# ADDENDUM NO. 1

**June 13, 2024**

## **PORTER COUNTY HIGHWAY DEPARTMENT – CENTRAL FACILITY**

This Addendum consists of Page ADD 1-1 through ADD 1-4, revised Specification Section 00 20 00 – Information Available to Bidders, attached Addendum No. 1 from A & Z Engineering, consisting of 1 page and 8 drawings, and attached Addendum No. 1 from MartinRiley, consisting of 4 pages, Specification Sections 00 01 10 - Table of Contents, 07 42 13 – Metal Wall Panels, 07 71 00 - Roof Specialties, 10 28 00 - Toilet, Bath, and Laundry Accessories, 11 11 19 - Vehicle Lubrication Equipment, 23 31 00 - HVAC Ducts and Castings, 41 22 00 - Hoists and Cranes, and 13 Drawings.

# C105

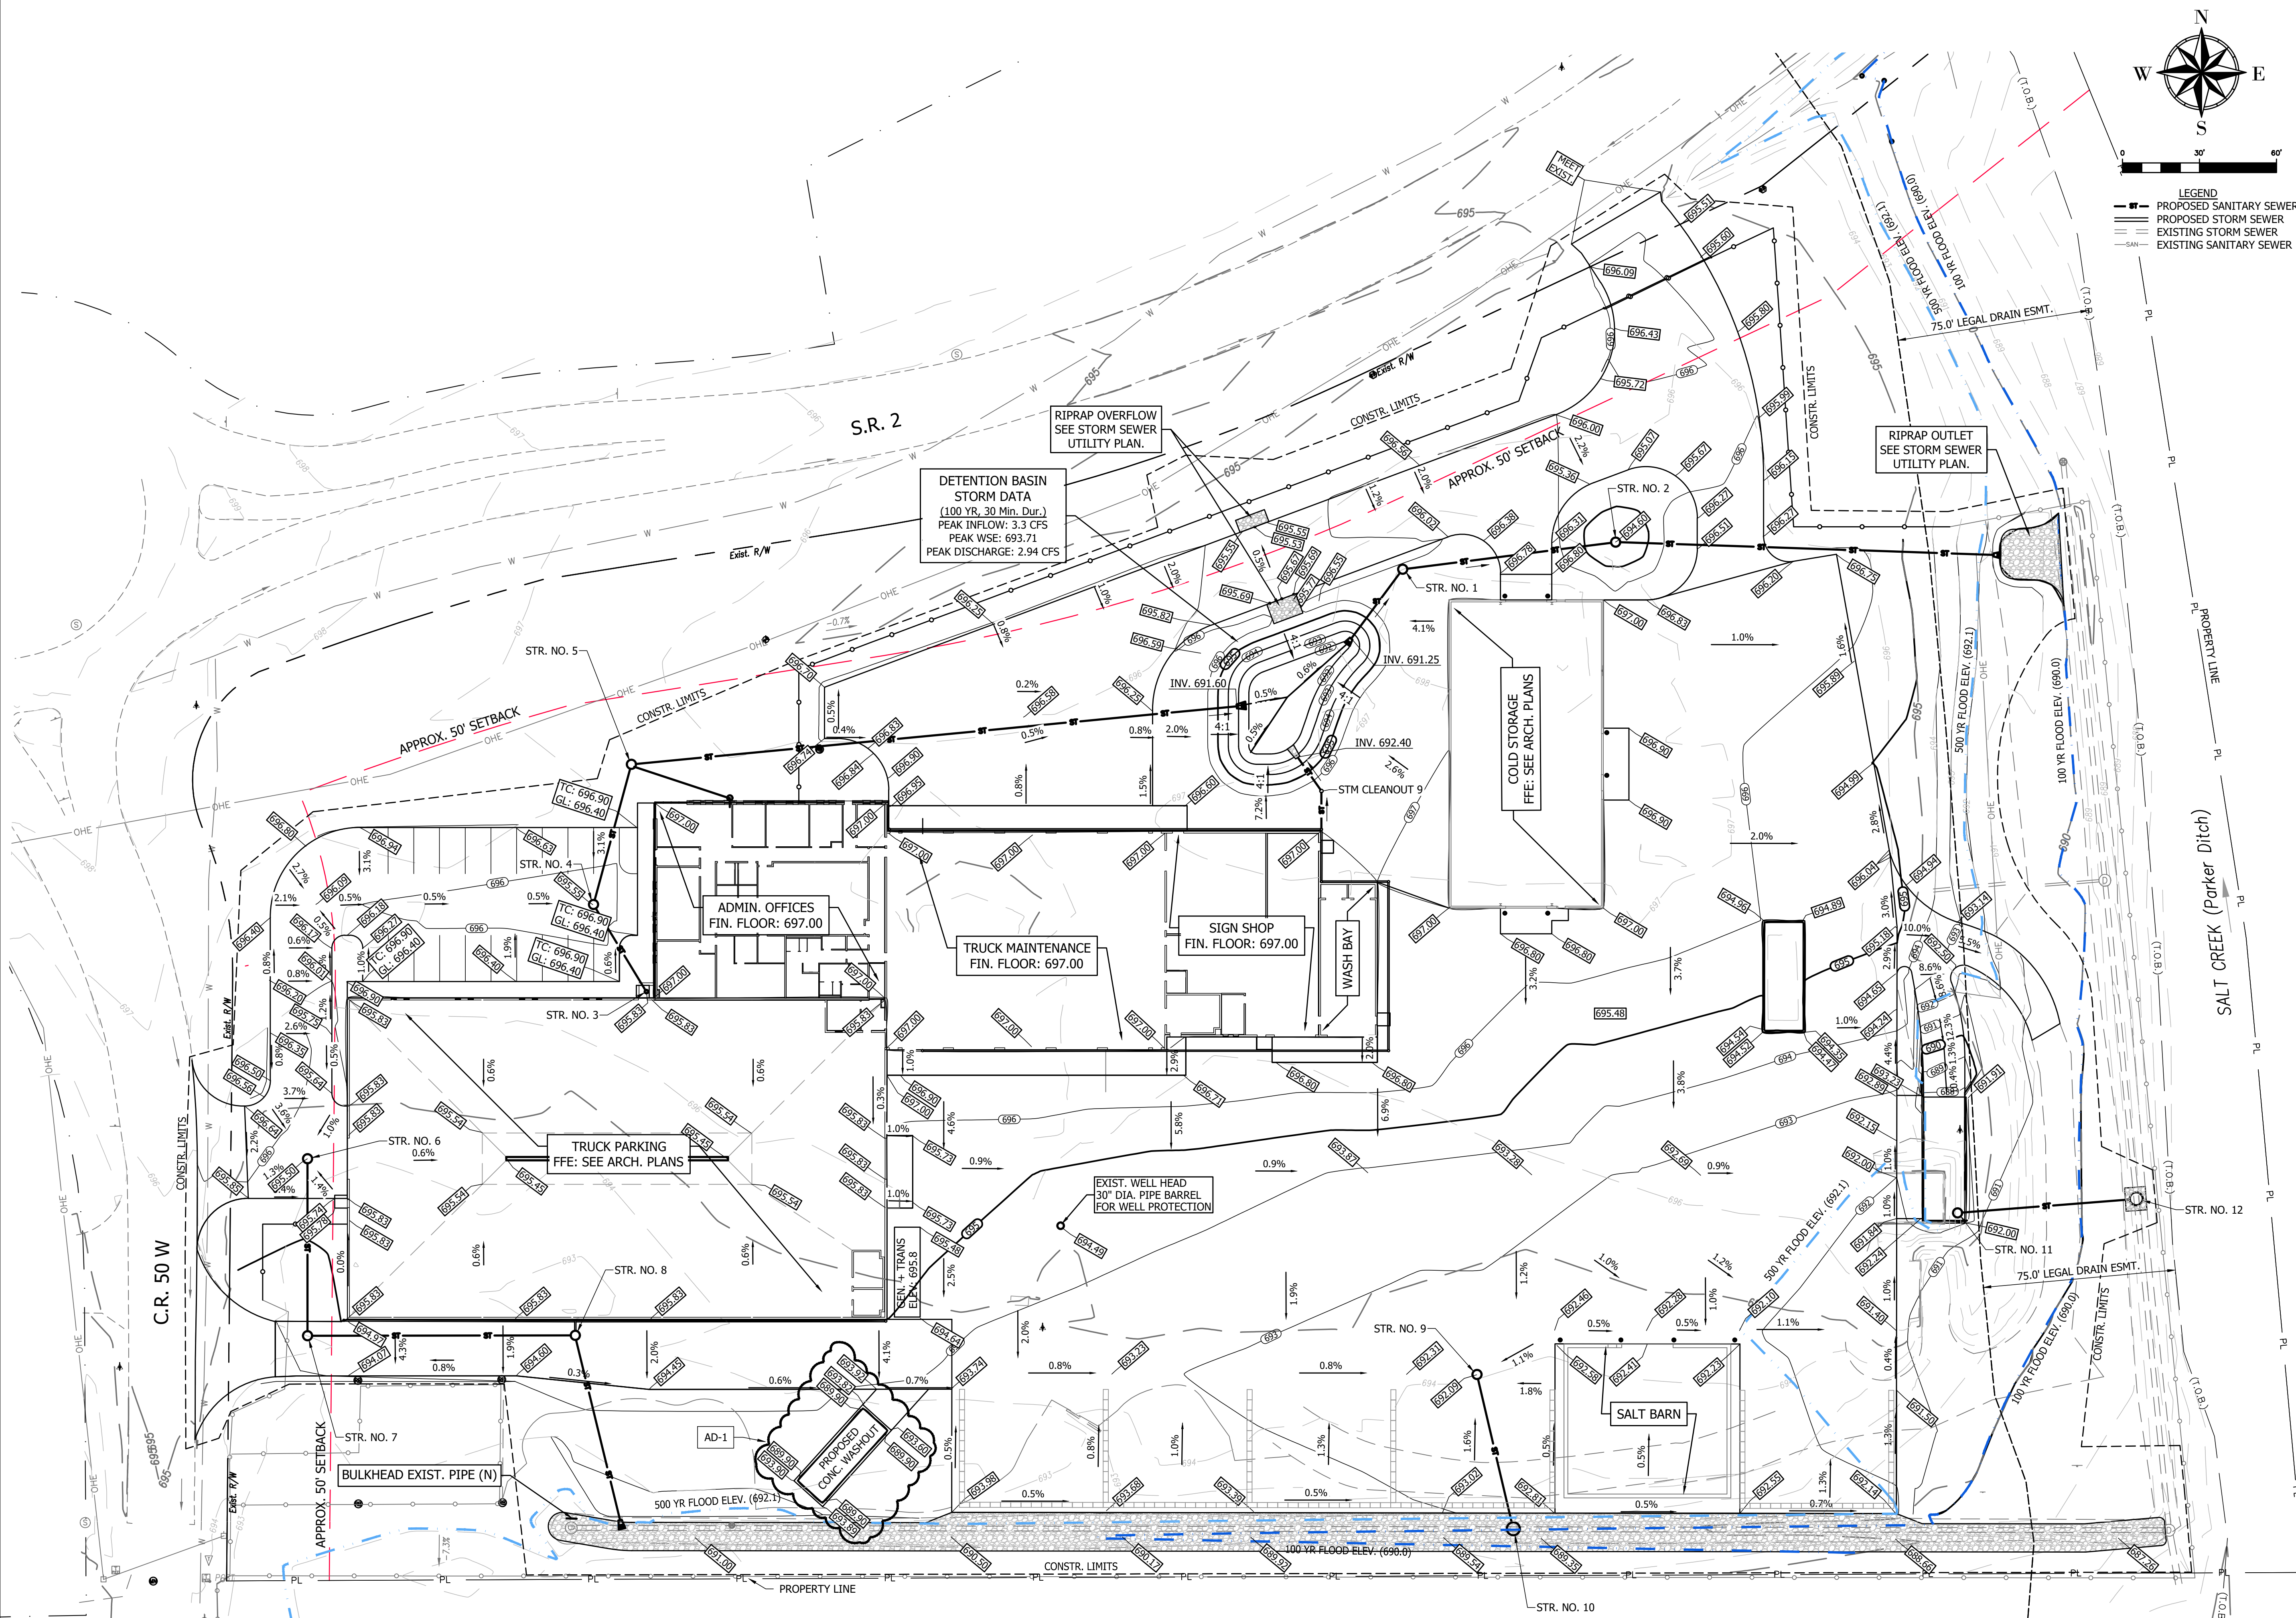
1. Sheet C105 – Site Plan
  - a. Revised dimensions of Aggregate Bays to reflect the actual size of the ecology blocks.
  - b. Added note that Aggregate Bays (Ecology Blocks) will be procured and installed by others.

- c. Added note to HMA for Mainline Legend item to clarify procurement and installation of materials.
    - HMA materials will be procured and installed by the County

# C106

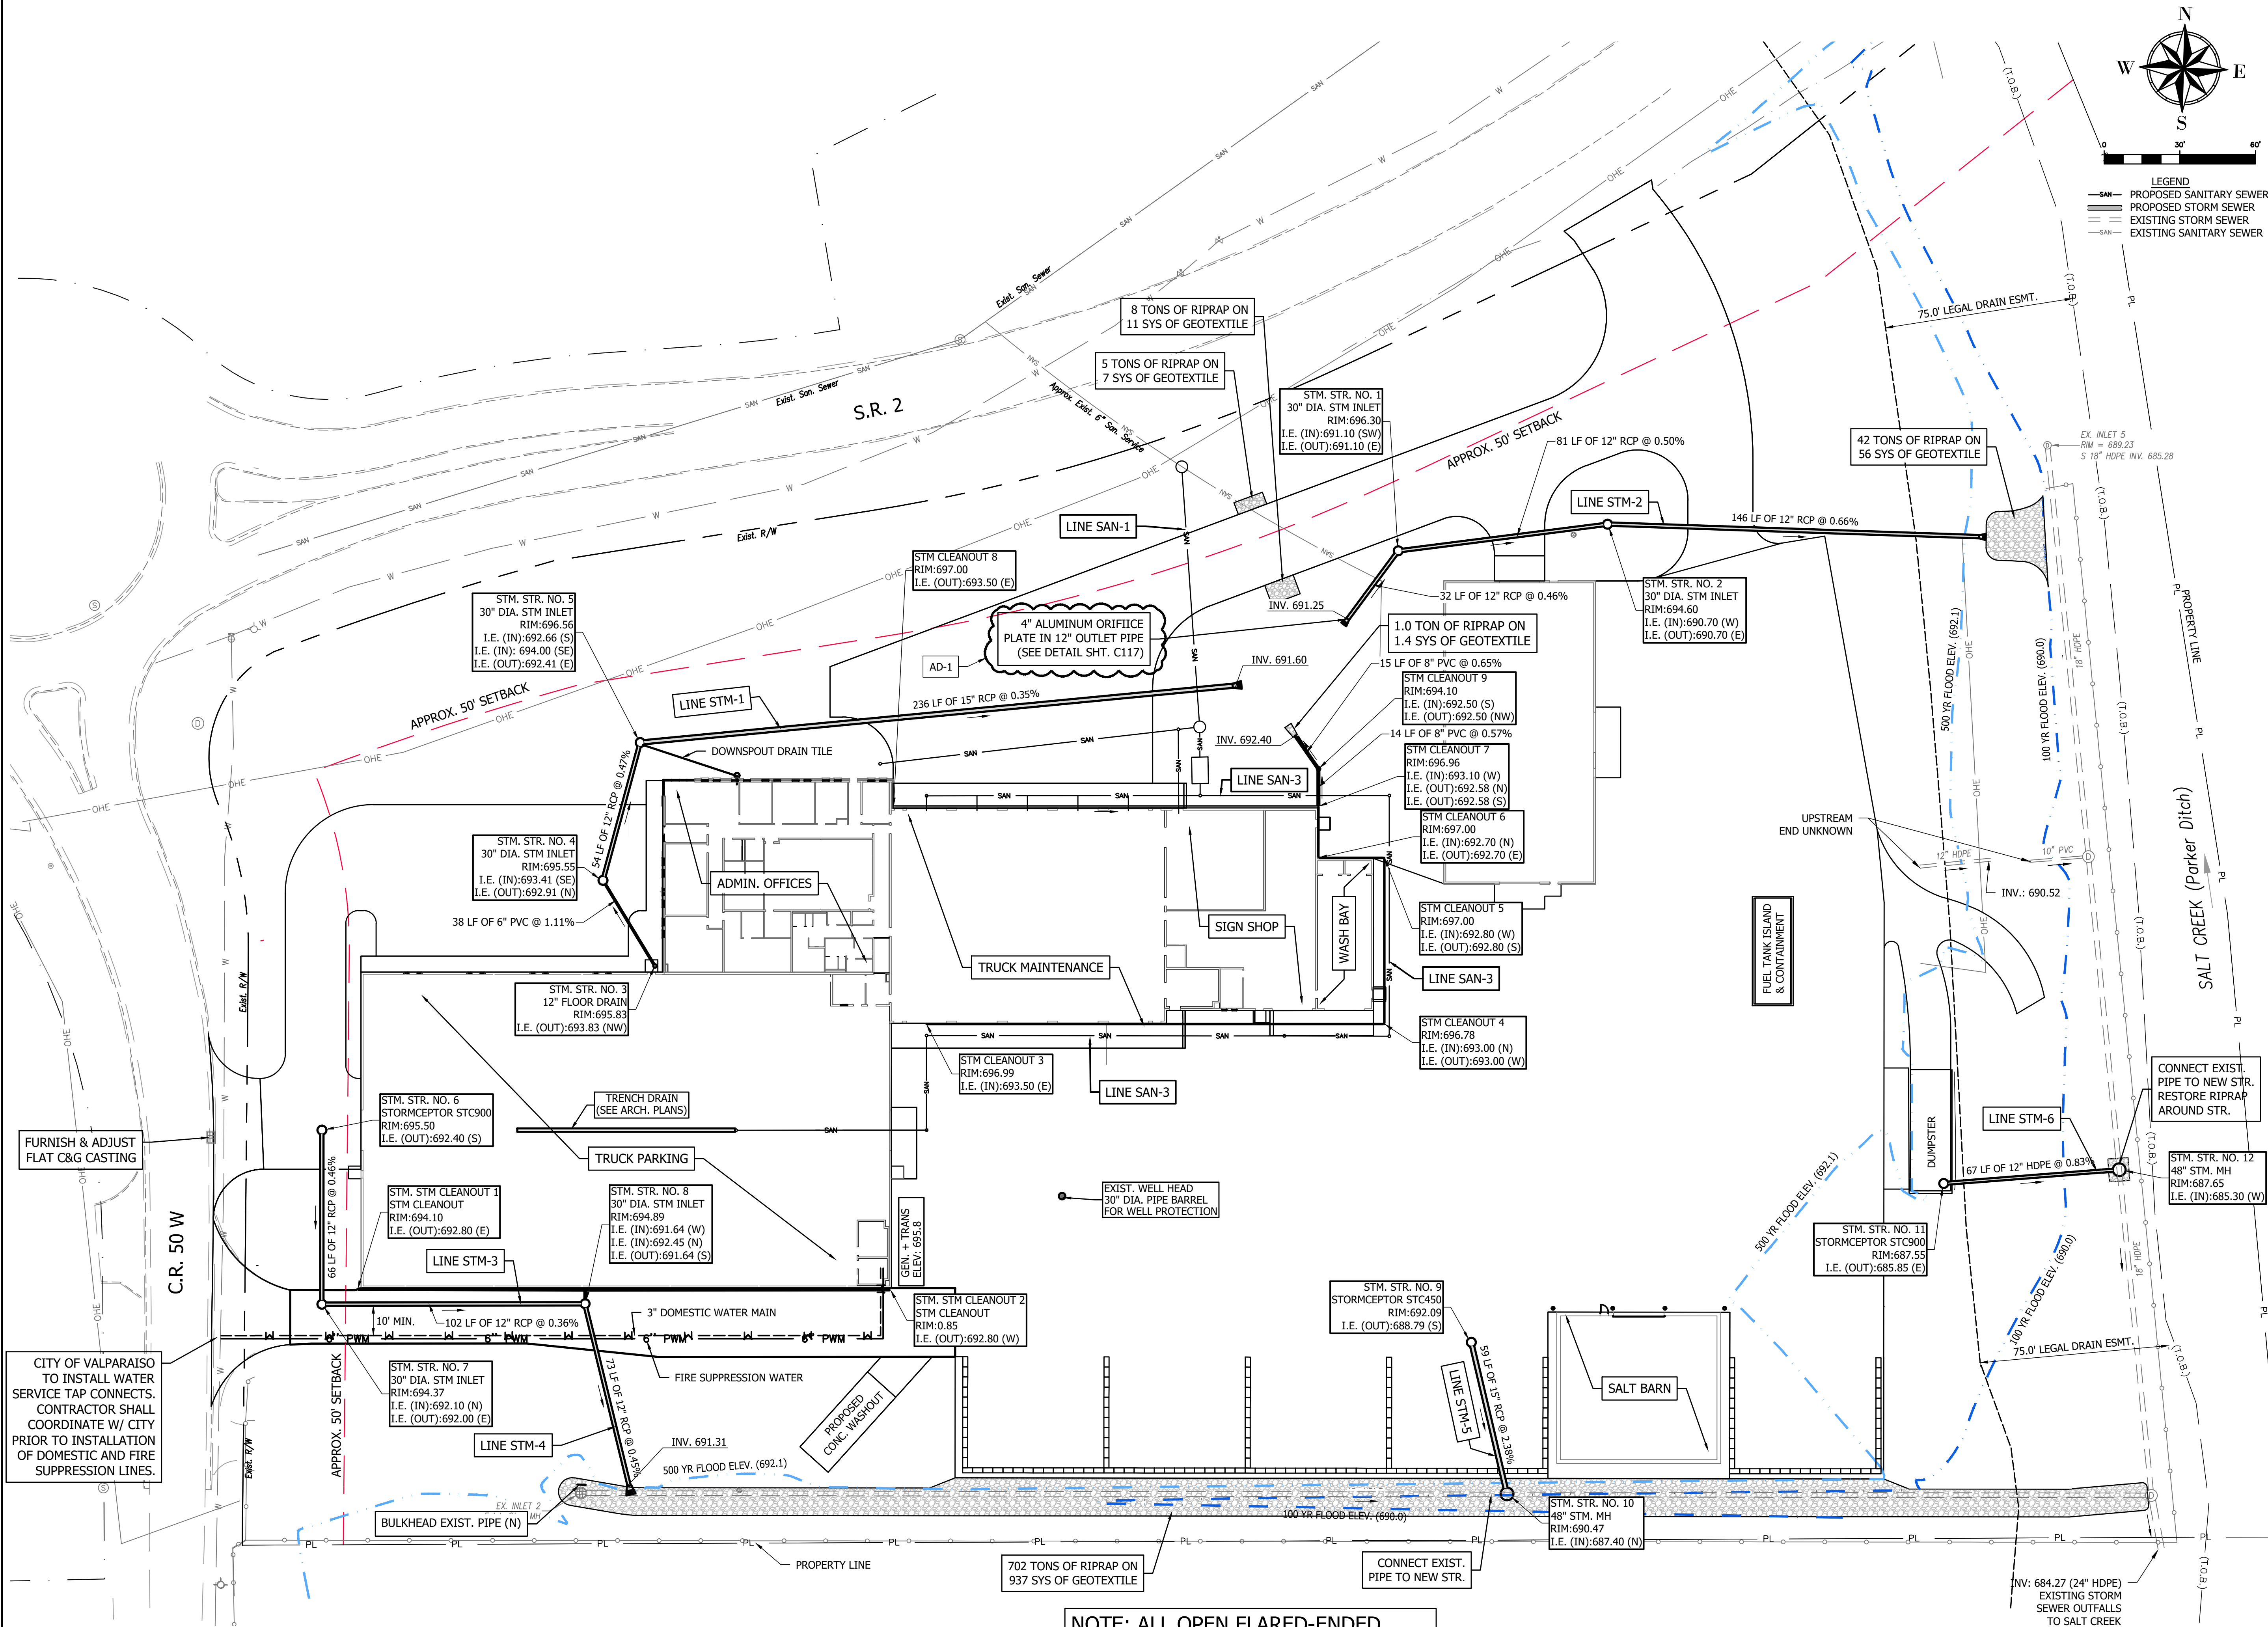
2. Sheet C106 – Grading Plan
  - a. Added spot elevations for the proposed Concrete Washout.
3. Sheet C109 – Storm Sewer Utility Plan
  - a. Added 4" Aluminum Orifice Plate to the basin's 12" outlet pipe.
